PRODUCT CHANGE NOTIFICATION (PCN)

| **PCN#**	WPC-180306-001	**Issuing Date**	March 06th, 2018

Product Name	Description	Supplying Schedule
W5500 Ethernet Shield	Revision: Rev1.0 → Rev1.1	March 06th, 2018

W5500 Ethernet shield Rev1.0	W5500 Ethernet shield Rev1.1

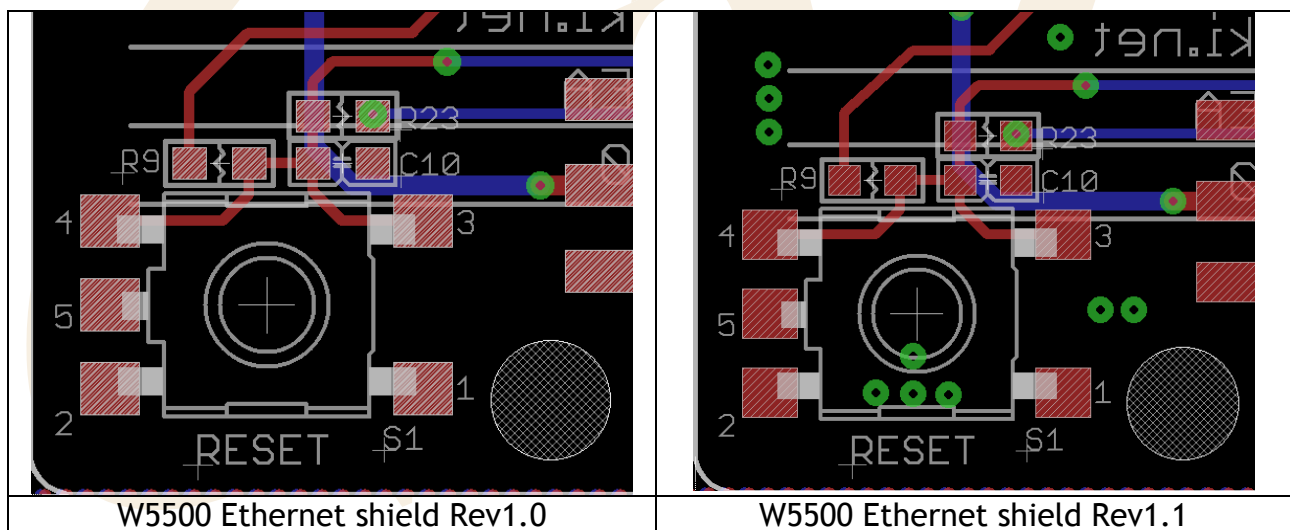
In Rev 1.0, GND pin of "RESET" button(S1) was floating.

This change in Rev1.1 will solve the floating problem. (Connect to GND with adding VIA.)
